**Subject:** FW: Riverkeeper Comments on Revised GEIS for NPP License Renewal, RIN3150-AI42 - E-mail 1  
**Attachments:** 2010.01.12.Riverkeeper Comments on Revised GEIS for Nuclear Power Plant License Renewal, RIN3150-AI42.pdf

Attached please find the comments of Riverkeeper, Inc. Riverkeeper in response to the U.S. Nuclear Regulatory Commission's Proposed Rule, "Revisions to Environmental Review for Renewal of Nuclear Power Plant Operating Licenses," 74 Fed. Reg. 38,117, 10 C.F.R. Part 51, RIN 3150-AI42, NRC-2008-0608 (July 31, 2009).

You should now be in receipt of Riverkeeper, Inc.'s Comments on the NRC's "Revisions to Environmental Review for Renewal of Nuclear Power Plant Operating Licenses," 74 Fed. Reg. 38,117, 10 C.F.R. Part 51, RIN 3150-AI42, NRC-2008-0608 (July 31, 2009), as well as Riverkeeper Exhibits, A, C, D, E, F, and G. Exhibit B, was too large of a file to be transmitted via e-mail, and will be included in the hard copy which will follow by mail.

Figure 4: The actual and estimated number of all life stages for striped bass at Indian Point. Log scale.

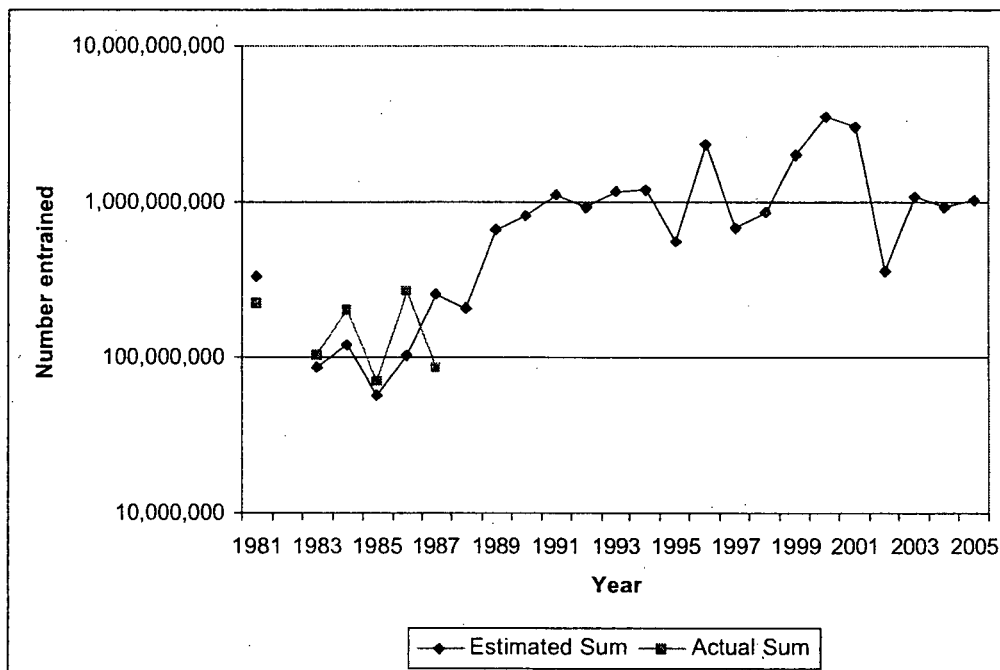
release eggs in the upper estuary, but spread steadily throughout the estuary as they grow. The relationship is better than that for American shad, but is still poor. The relationship for striped bass (Figure 4) is good, as the bass breed close to Indian Point. This is demonstrated in Figure 5, which shows the river regions where various striped bass life stages are found in the estuary.

The striped bass calculations demonstrate that present entrainment estimates based on the old estimates in the DEIS would be underestimated. The average number of striped bass entrained in 1981-7 was 46 million. Using the estimates presented in Figure 4, the average number entrained between 1987 and 2005 was 366 million, an increase of over 750%.

**Figure 11: The extent of the thermal plume from the cooling water discharge of Indian Point Unit 3, and the Lovett generating station.**

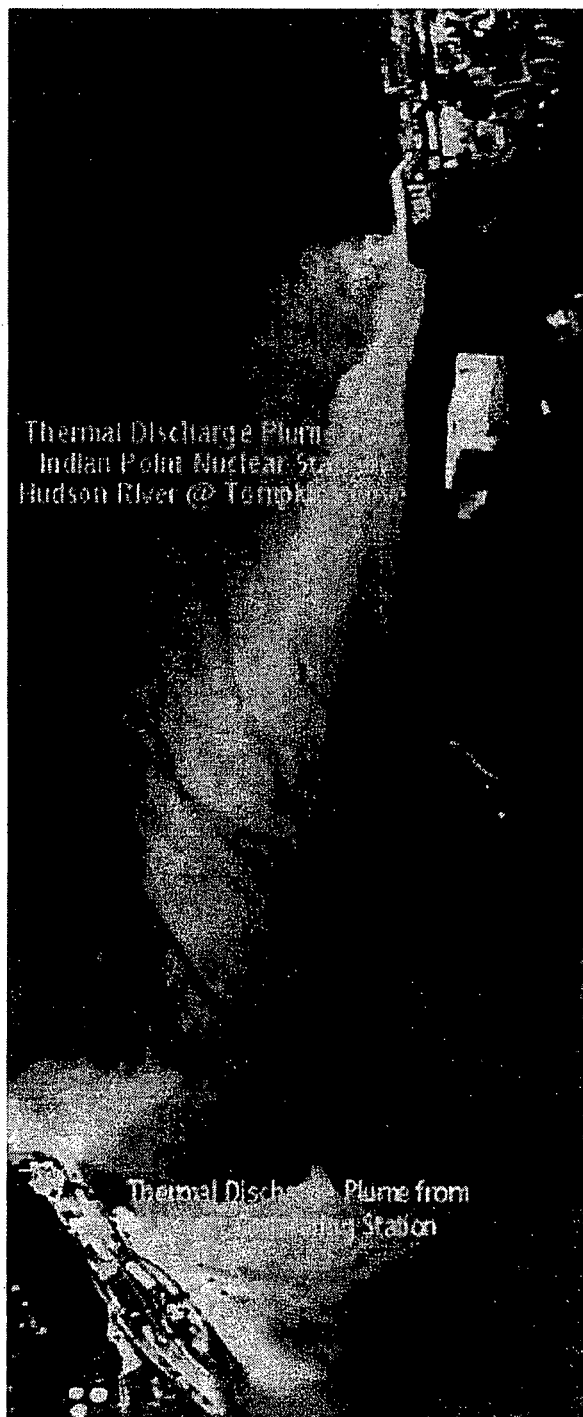
Infrared images highlight the surface extent of the thermal plume released from Indian Point (Figure 11). The image below, taken from the FEIS, shows the high proportion of the width of the river that is impacted by the Unit 3 discharge of Indian Point. The following quotation describes the concern:

Figure 12: Temperature profile of the Hudson River, NYC to Newburgh, during a neap tide. From the FEIS and originally HydroQual, 1999.

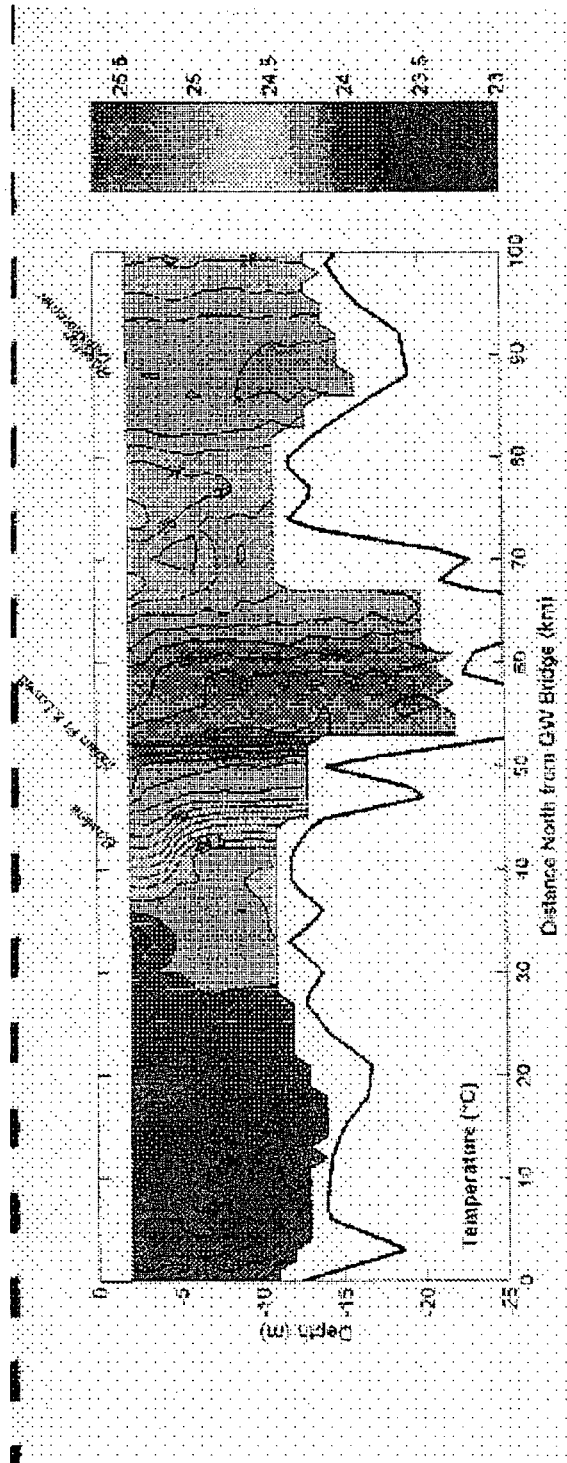
impact bottom-living and deep-water species. Such deeper water penetration of the thermal plume is always a matter for concern, as it may lead to damage to the benthic food chain and also not allow migrating fish to pass under the heated water plume. It is clear that almost the entire vertical water column in the vicinity of Indian Point holds water heated above background temperatures (Figure 12). The FEIS states:

Figure 13: Plot of the maximum daily discharge temperatures at Indian Point 2000-2007. The 90° and 100°F reference levels are shown in red.

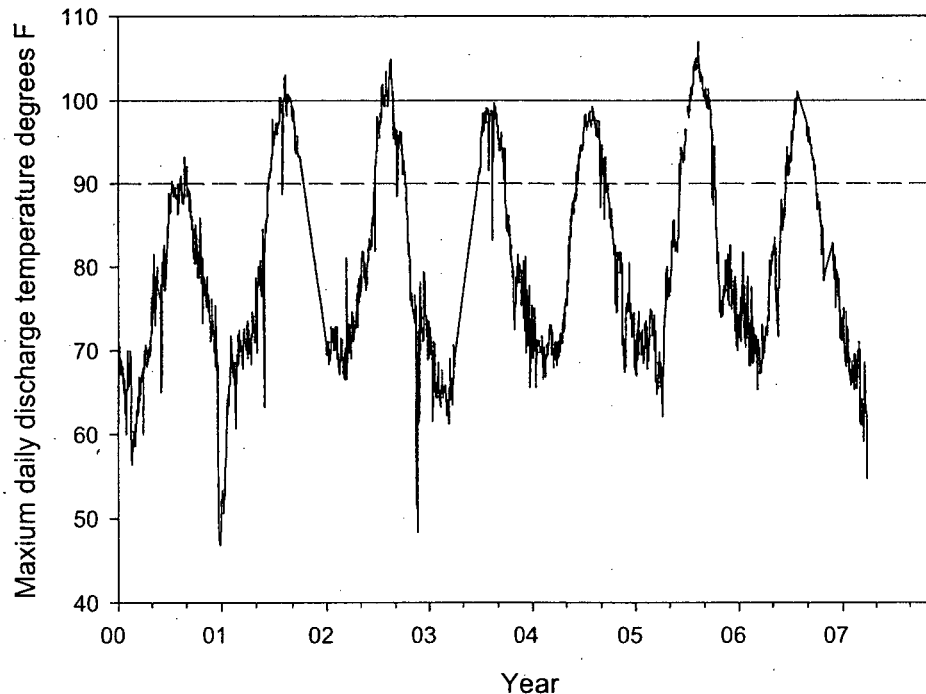
Figure 13 shows a plot of the maximum daily discharge temperatures at Indian Point, with the 90° and 100°F reference temperatures shown in red. Note that 90°F has been exceeded for extended periods every summer since 2001. Furthermore, 100°F has been exceeded in 3 of the 7 summers for which data are plotted.

Figure 14: A sample of the results presented for the far field temperature effects of the Hudson Estuary power plants. From the DEIS for Roseton, Bowline and Indian Point generating stations.

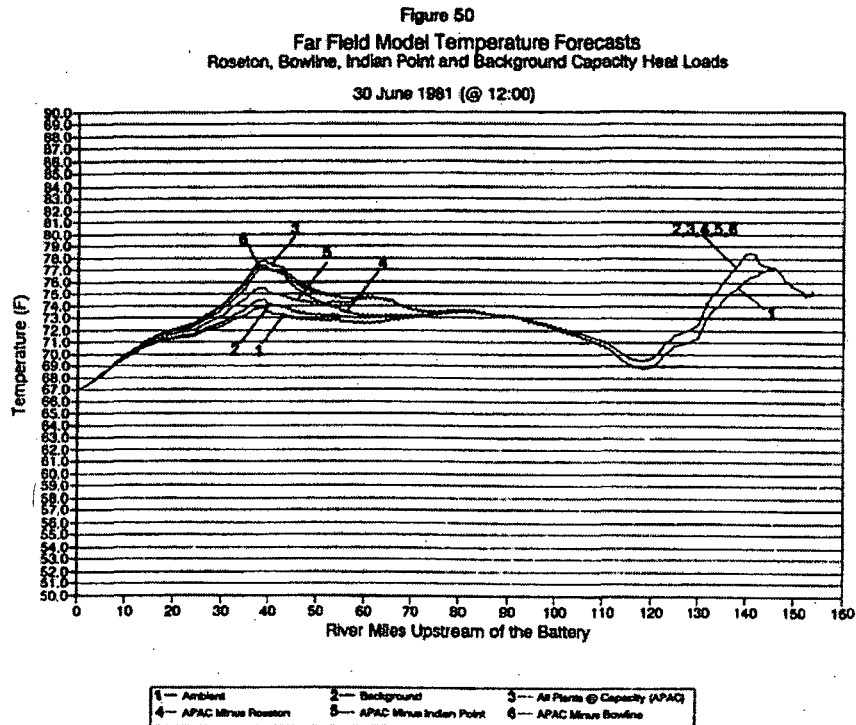
The Massachusetts Institute of Technology dynamic network model was reported in the DEIS for a range of power plant discharge scenarios. A typical output is presented in Figure 14. A comparison of lines 3 and 5 show the appreciable effect of Indian Point generating station, which was predicted to increase river temperature by  $> 1^{\circ}\text{F}$  for more than 10 miles of estuary.

**Figure 2: The standardised juvenile index for white catfish in the Hudson; showing a decreasing trend though time.**

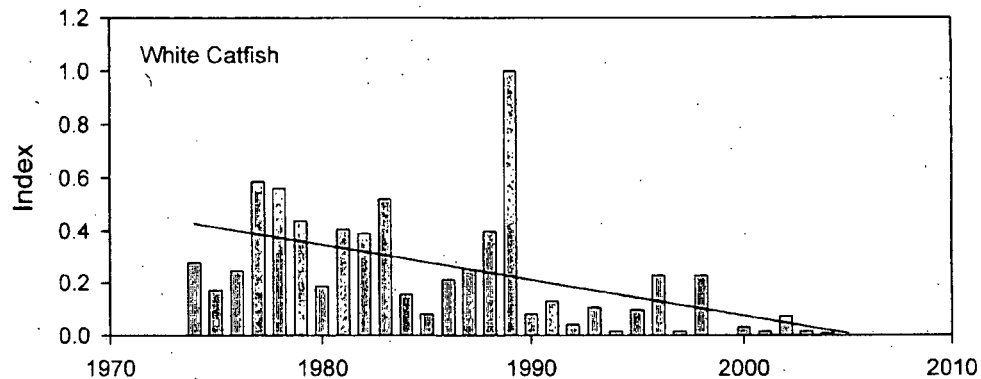
The Year Class Reports for the Hudson River Estuary Monitoring Program shows that, river-wide, juvenile white catfish have been in a steep decline in abundance since 1990 (Figure 2).

It is therefore unsurprising that in Table 4-4 (see Figure 1) the population line of evidence is for a 'Large' potential adverse impact. The trend shown in Figure 2, which is statistically significant, certainly seems to correspond with the definition of Large given on page H-33, NUREG-1437, Vol 2:

Figure 3: The standardised juvenile index for weakfish in the Hudson showing a decreasing trend though time.

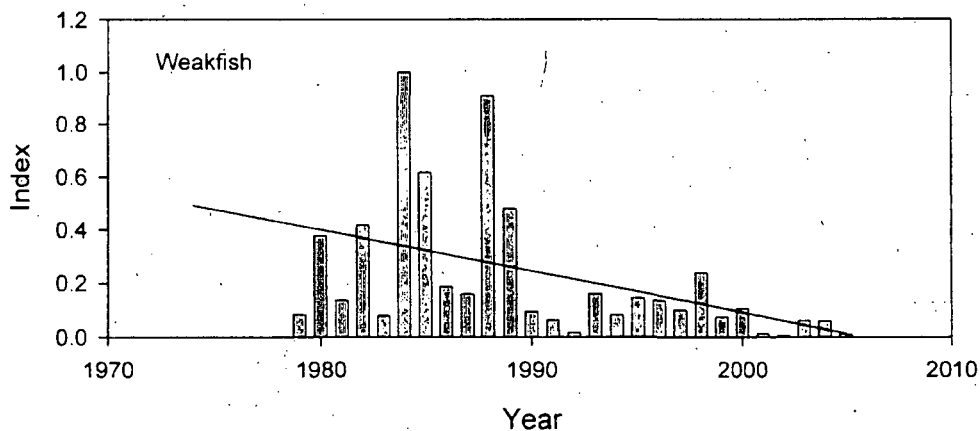
Like white catfish, weakfish have also shown river-wide a steep decline in abundance since 1990 (Figure 3). However, unlike white catfish, for this species Table 4-4 classifies the population line of evidence as 'Small'.

Figure 5: The standardized juvenile index for rainbow smelt in the Hudson.

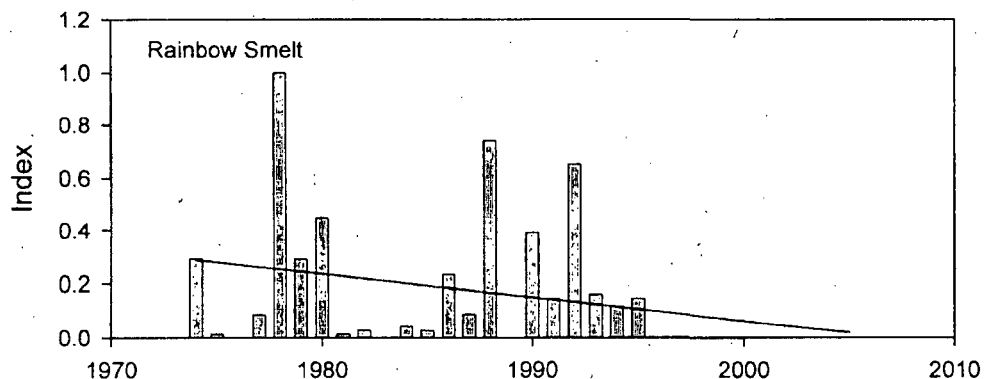
Juvenile rainbow smelt have disappeared from the survey since the mid 1990s (Figure 5), and it is therefore unsurprising that Table 4-4 assesses the population line of evidence as 'Large'. However, the impact of Indian Point 2 and 3 is assessed as moderate because the strength of connection is assessed as 'Medium'.

Figure 6: The standardised juvenile index for tomcod in the Hudson showing a decreasing trend though time. (Seaby and Henderson, 2007)

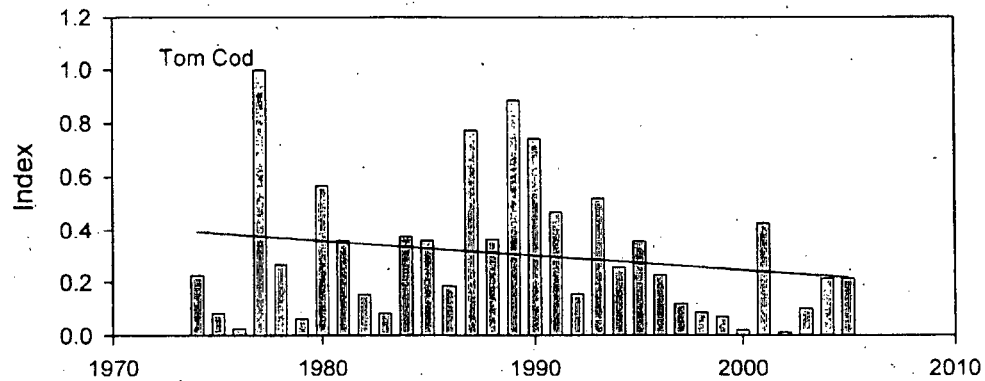
Examination of Table I-32 (Figure 4) shows that a number of the RIS species have a prey score for impingement and entrainment of 1, and thus are unlikely to score highly for the strength of connection. This feature of the scoring protocol is thus central to the final outcome. The Atlantic tomcod makes a telling further example. The tomcod population shows considerable year-to-year variation, but appears to be in long-term decline (Figure 6). The average standardised index from 1975 until 1995 is 0.158; in comparison the index for the last ten years of sampling (1996-2005) is only 0.0617. In the last 10 years, only 2001 produced a good recruitment, although there are signs of a recent slight improvement in tomcod numbers.
